AMENDMENTS TO THE DRAWINGS:

Appl.No. 09/846,707
 Amdt. Dated November 4, 2004
 Reply to Office action of October 20, 2004
 Replacement Sheet

FIG. 5A

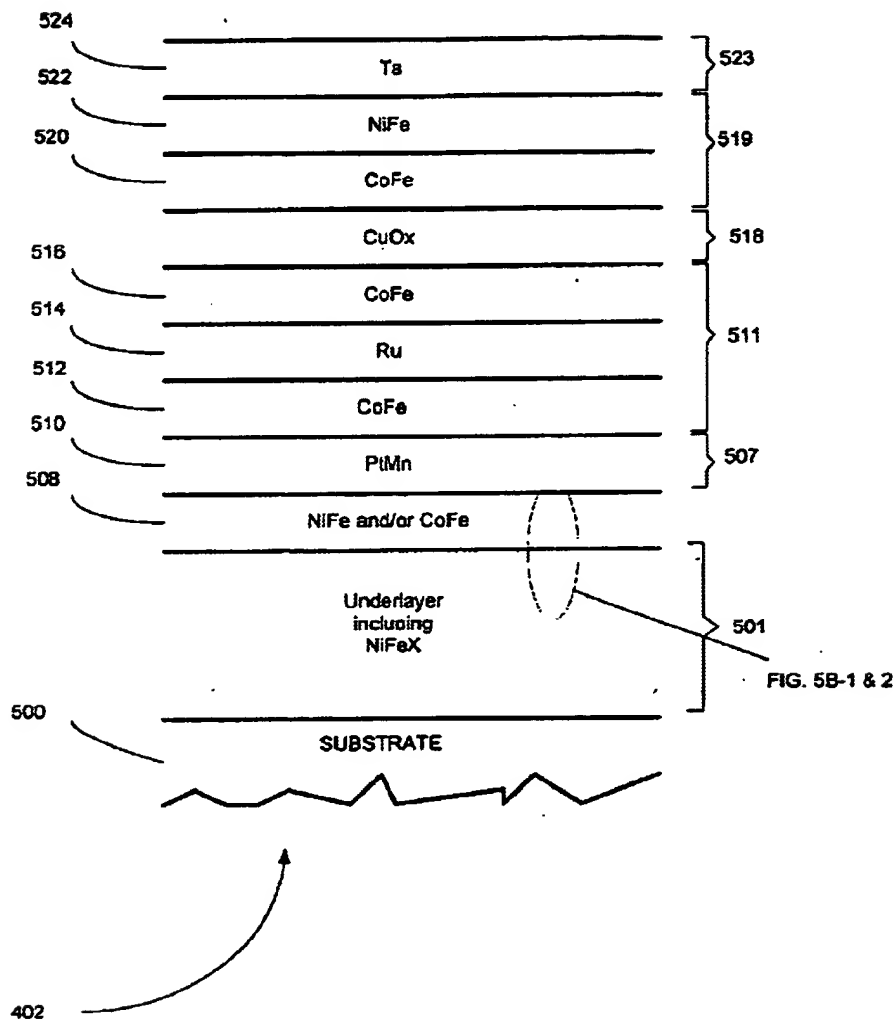
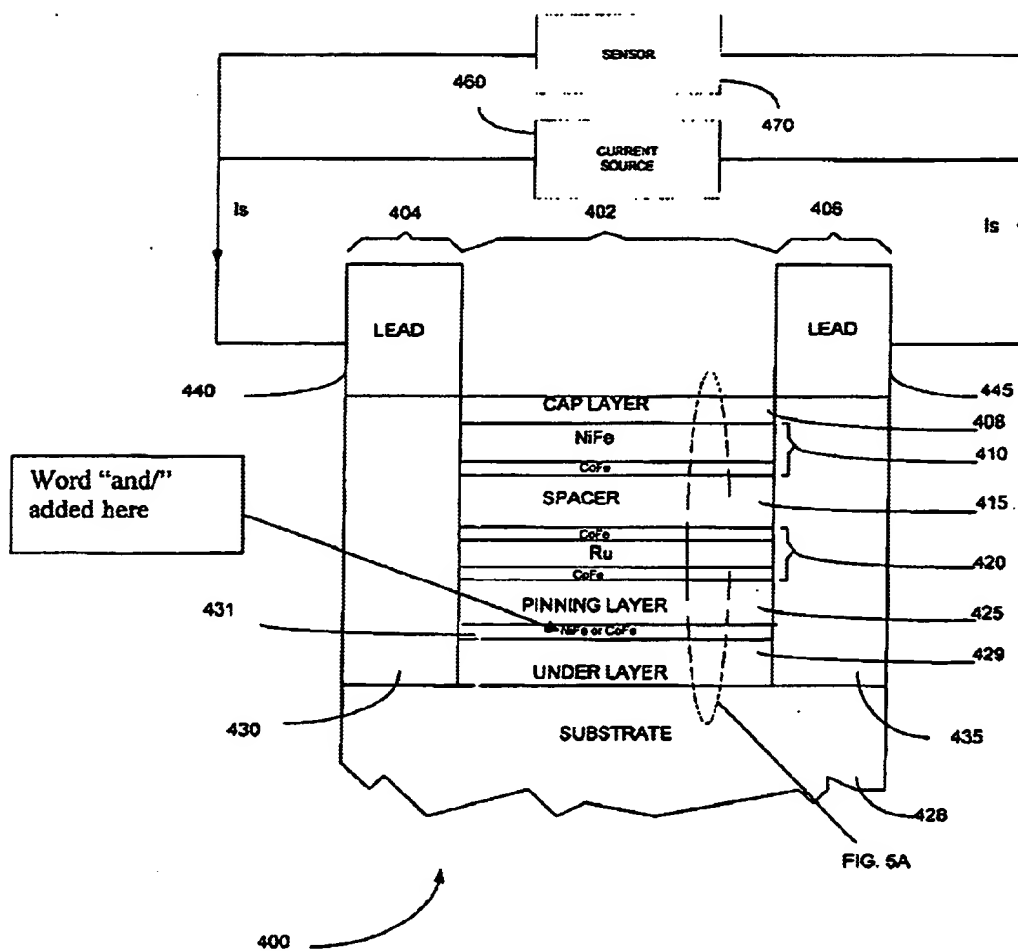
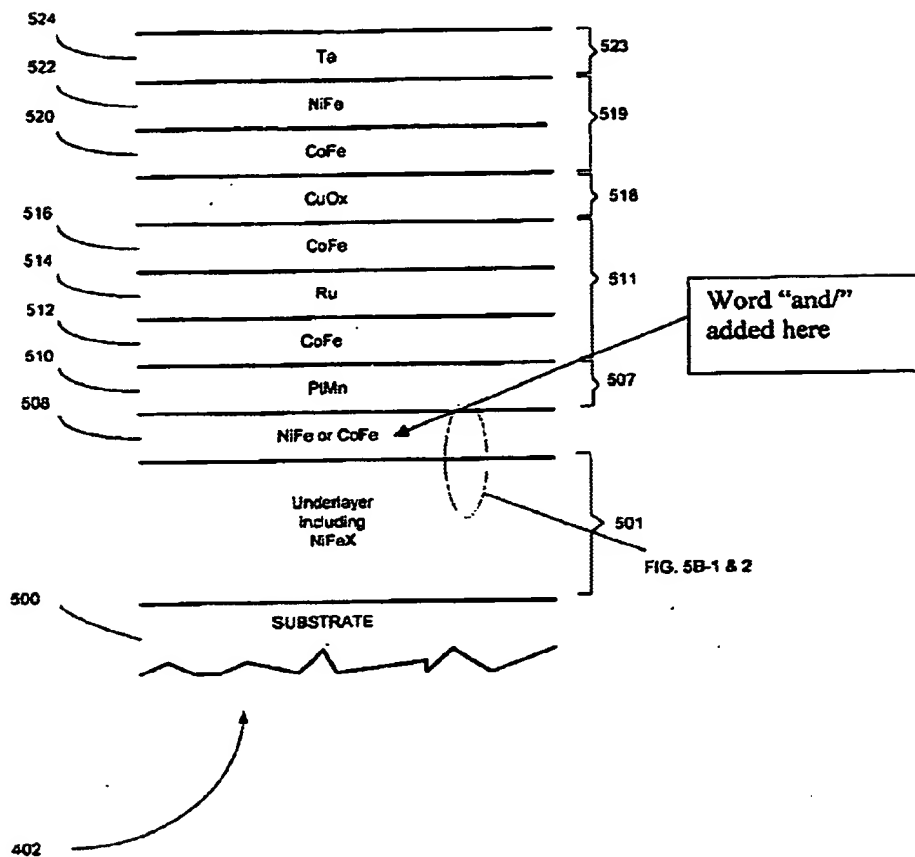
The Examiner has objected to the drawings for failing to show the claimed feature that the upper layer include NiFe and CoFe. The attached sheets of drawings includes changes to Figs. 4 and 5A. These sheets, which include Figs. 4 and 5A, replace the original sheets including Figs. 4 and 5A. In Fig. 4, the upper layer 431 is shown to include NiFe and/or CoFe. In Fig. 5A, the upper layer 508 is shown to include NiFe and/or CoFe.
